PROJECT: Pavement Maintenance at Various Sites

OWNER: Clovis Unified School District

BID NO: 2984

BCF PROJECT NO. 222-0431

Sheet CE-30(AD1)

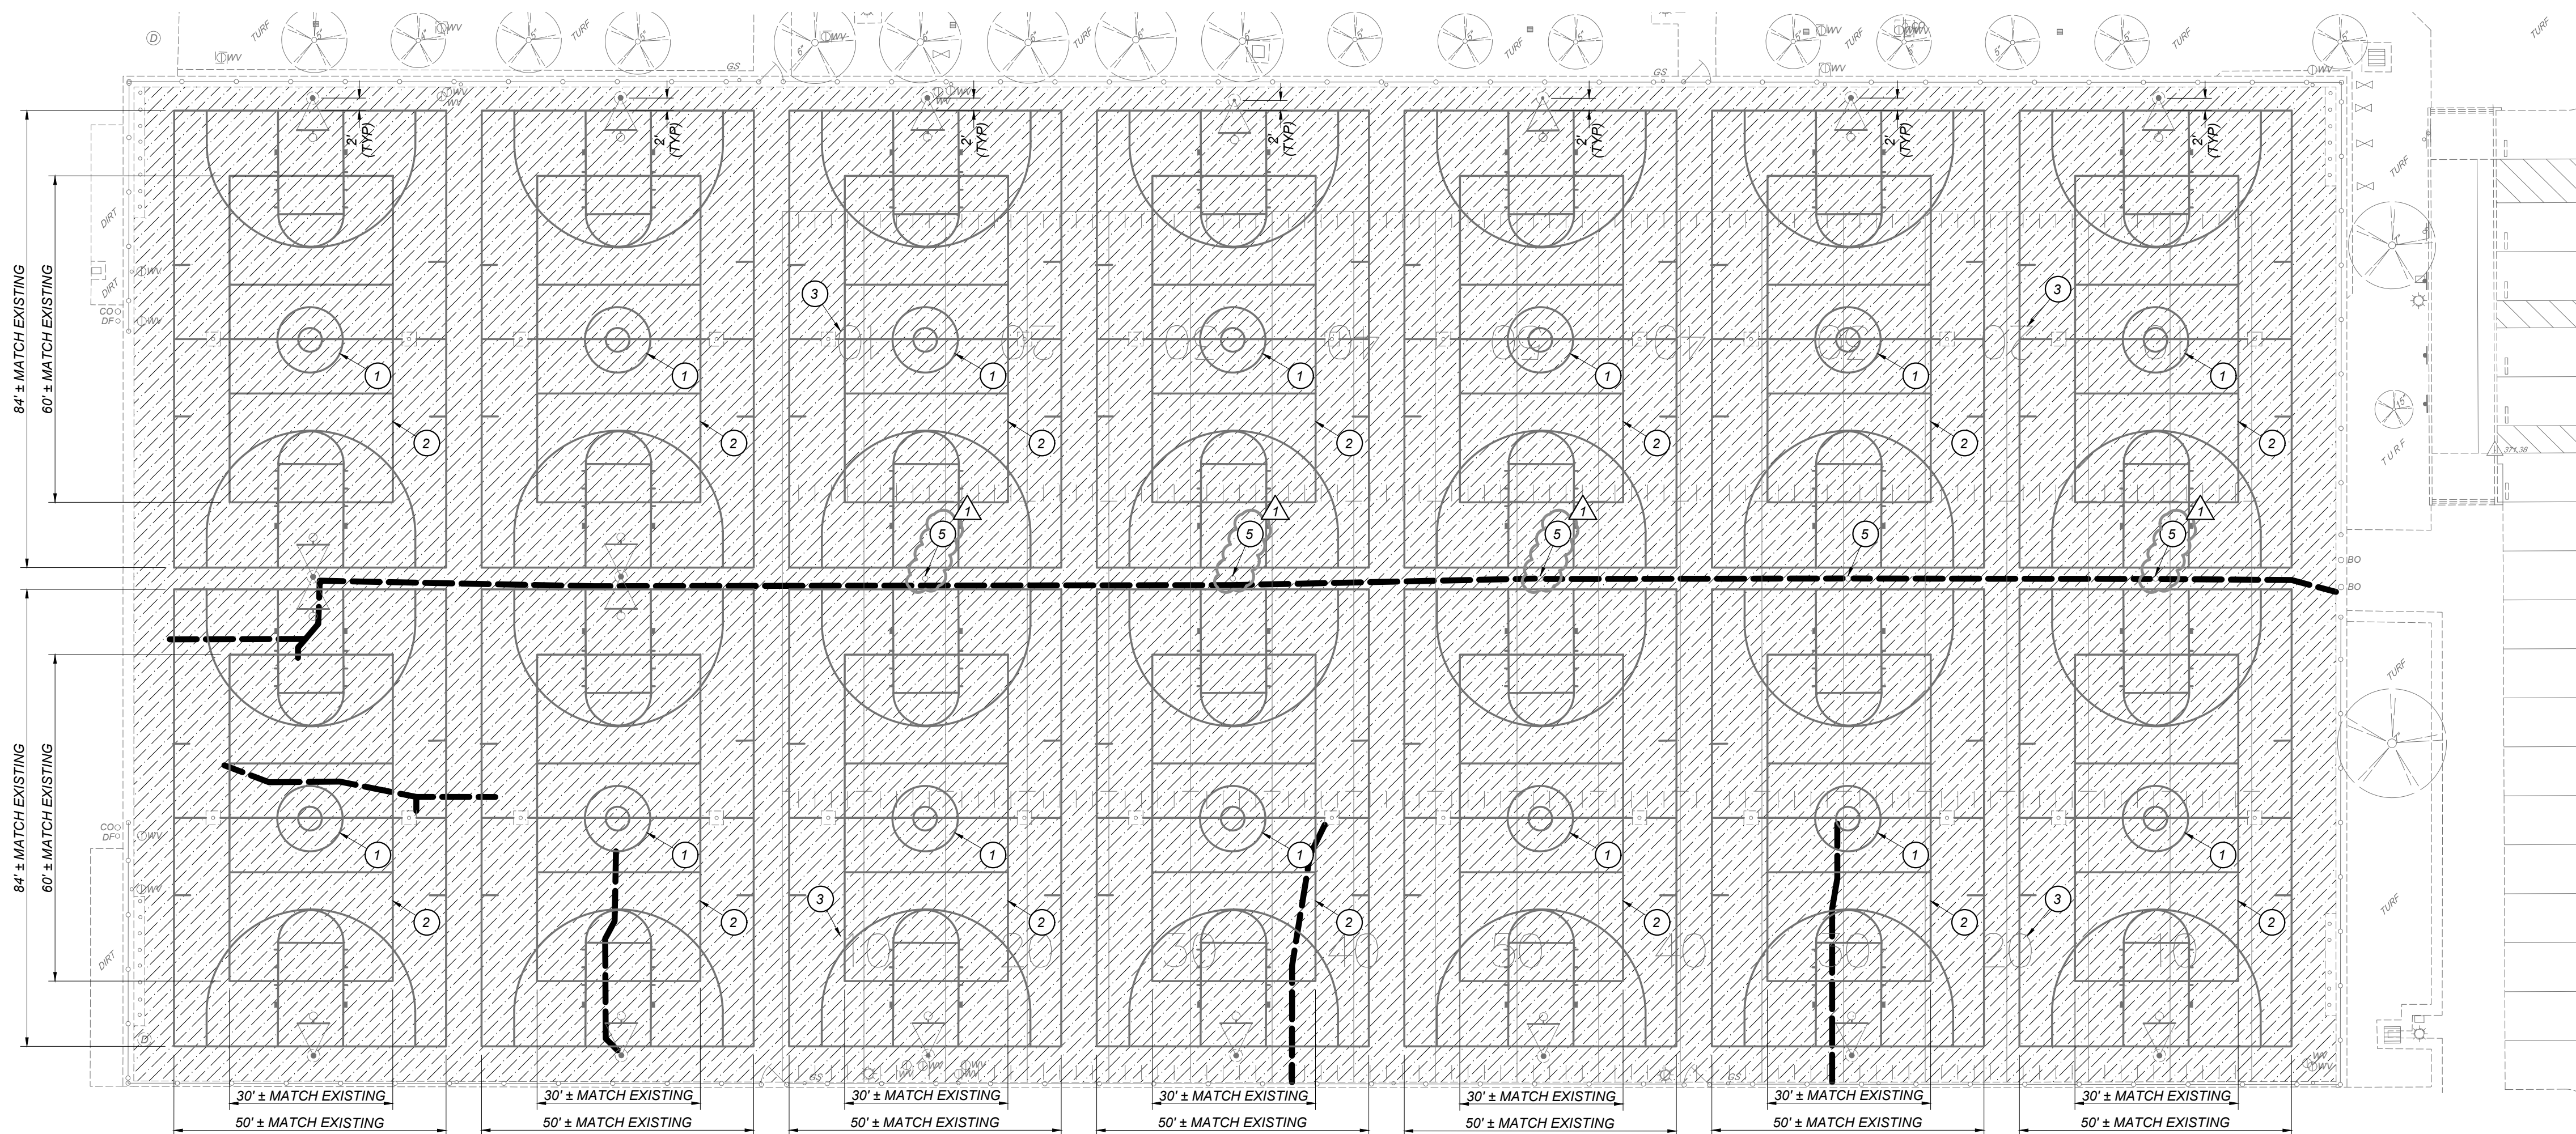
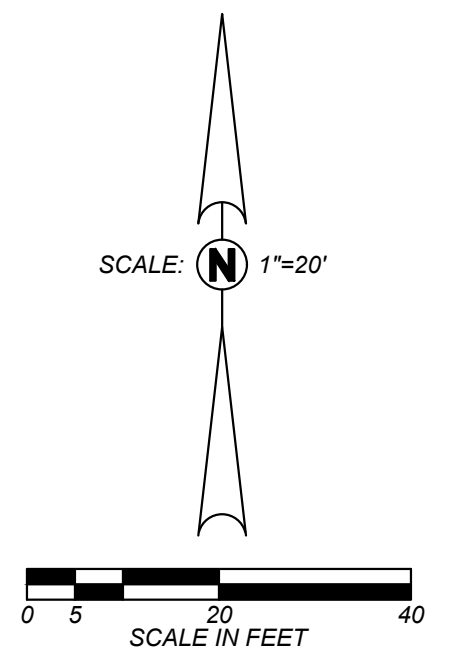
Replace sheet CE-30, with the attached sheet CE-30 (AD1). Additional information has been added to clarify the dimensions for the playcourt striping. All changes have been clouded and delta'd
